July 12, 2019

**Re: Permanente Quarry, Mine ID # 91-43-0004**  
**Response to April 29, 2019, Incompleteness Letter and Resubmittal of Utility**  
**Road Reclamation Plan Amendment**

# **PERMANENTE QUARRY RECLAMATION PLAN MINOR AMENDMENT FOR THE UTILITY ROAD RECLAMATION AND BOUNDARY ADJUSTMENT**

## Utility Road Grading Plan and Geotechnical Analysis

Utility Road Grading Plan

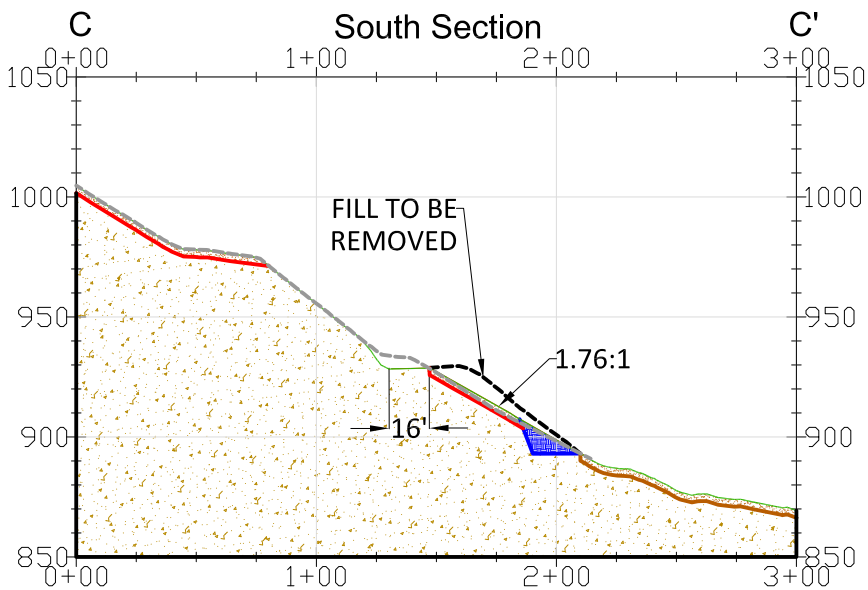
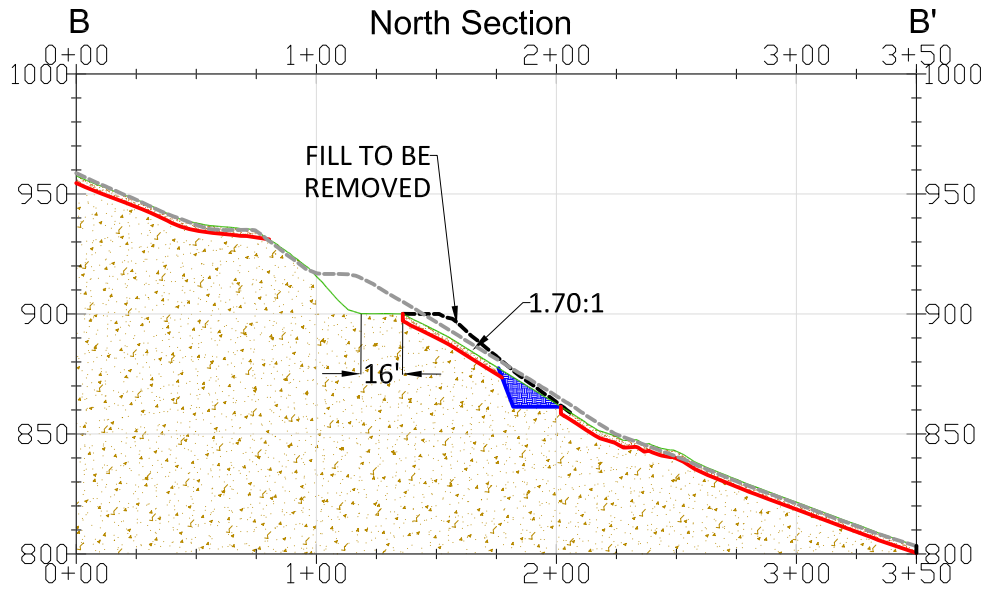
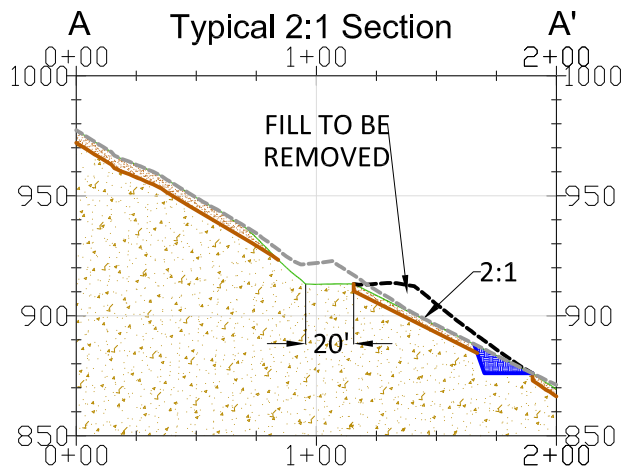
The County next requested that Lehigh submit a grading plan that identifies how fill slopes (which presumably refers to fill slopes in the utility road area) will be reconfigured to 2.0H:1.0V or flatter "in order to provide long-term stability (factor of safety ["FOS"] greater than 1.0) under earthquake loading conditions."

Stantec recommends grading the road to reduce fill slope gradients to comply with local rules and regulations. City and County grading regulations require slope gradients be 2h:1v, or the design be certified by a Certified Engineering Geologist. The grading design is based on a minimum 20-foot road width, which includes sufficient space for one-way travel, a ditch, and a berm. Road widths for retained roads, in the currently approved Reclamation Plan Amendment for the Permanente Quarry, vary and are as narrow as 12 feet. Wherever practical, the road will be wider than 20 feet to provide turn-off locations. The grading plan has an overall road gradient of approximately 12%, with short sections that exceed 20% gradient. These grades are consistent with the original utility road and other roads that will be retained during reclamation per the currently approved Reclamation Plan Amendment for the Permanente Quarry.

Nonetheless, in light of the County's comments, Lehigh asked Stantec to consider options for flattening the fill slope and increasing the FOS. After further analysis, Stantec concluded that it is possible to reduce the fill slope angle to 2.0H:1.0V along the vast majority of the length of the road (except for two areas where the original topography was steeper, which are within the City of Cupertino jurisdiction). This redesign increases the pseudo-static FOS to 1.41 or greater for all road segments. Lehigh includes the revised design as part of its application resubmittal.

As noted above, however, Lehigh has continued to analyze options for redesigning the road. Flattening the fill slope to 2.0H:1.0V, as described above, would serve to narrow the width of the road to approximately 20 feet in most areas within the revised reclamation plan boundary. Lehigh will, as noted above, include this design change in its resubmittal.

The road can be graded to 2h:1v slopes the entire length of the road, except for two areas as shown on **Drawing 1**. Both sections where steeper slopes are required are approximately 100 feet long. The grading for both areas includes narrowing the road width to 16 feet and increasing the slope gradient to the necessary slope that does not increase the disturbance area beyond the existing area. Narrowing the road to 16 feet allows the slope gradient to be decreased closer to the 2h:1v target, while maintaining sufficient road width for the potential traffic. The northern section requires a maximum gradient of 1.70h:1v, and the southern section requires a maximum gradient of 1.76h:1v. These gradients follow the pre-construction topography; therefore, the entire length of road will be graded to 2h:1v slopes or to pre-construction topography. This grading requires excavating and hauling away approximately 9,000 cubic yards of material. The material will be placed on the Permanente Quarry property in accordance with the current Reclamation Plan.

**VIEWPOINT 3:** CANYON VIEW CIRCLE LOOKING NORTHWEST

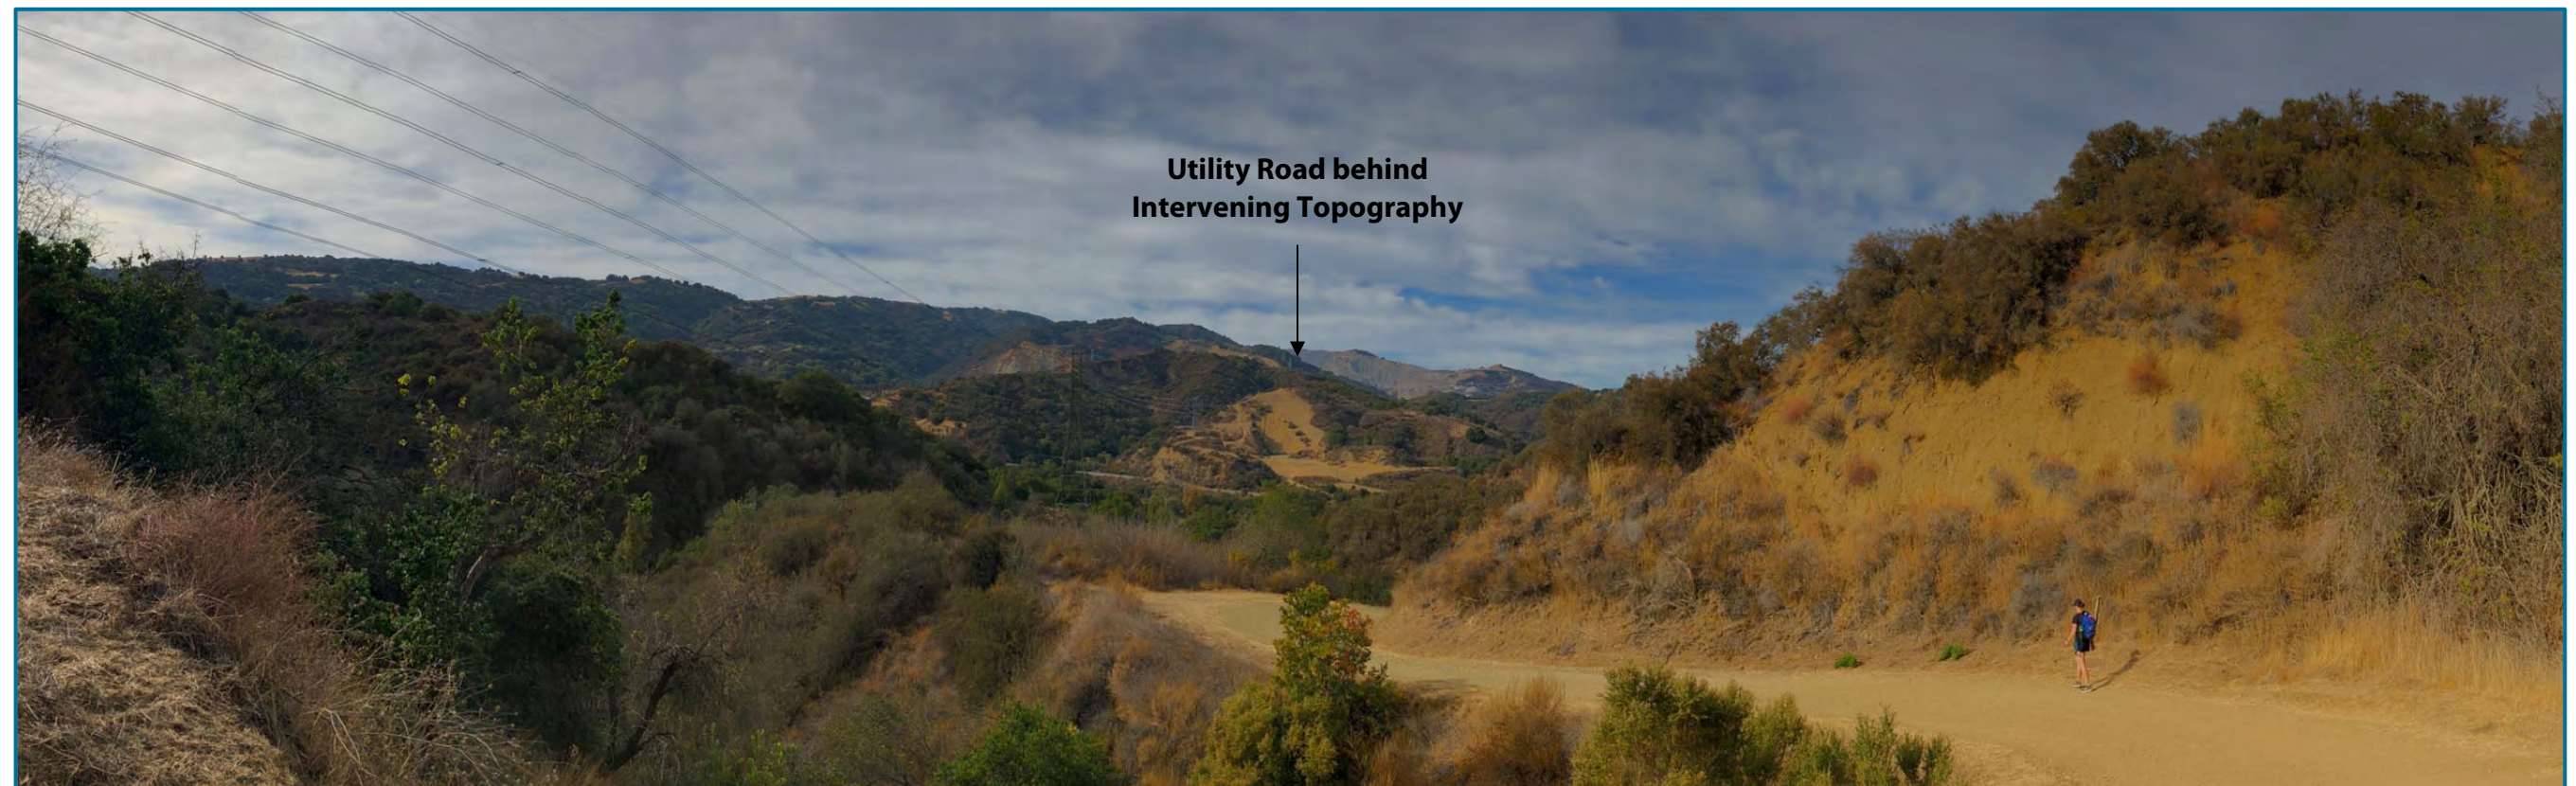
The County also requests a viewshed analysis showing the visibility of the existing utility road from public roadways. The requested visibility analysis is enclosed.

A portion of the utility road can be seen just below the Stevens Creek Quarry mined area, as labeled on the Viewpoint 3 photograph in Figure 4. This portion of the road is visible, but does not stand out as noteworthy in relation to the surrounding surface disturbance. After the slope above the road is vegetated to control erosion, the portion of the road visible from this viewpoint would not contrast with the surroundings. Reclamation would further reduce visibility of the road from this viewpoint.
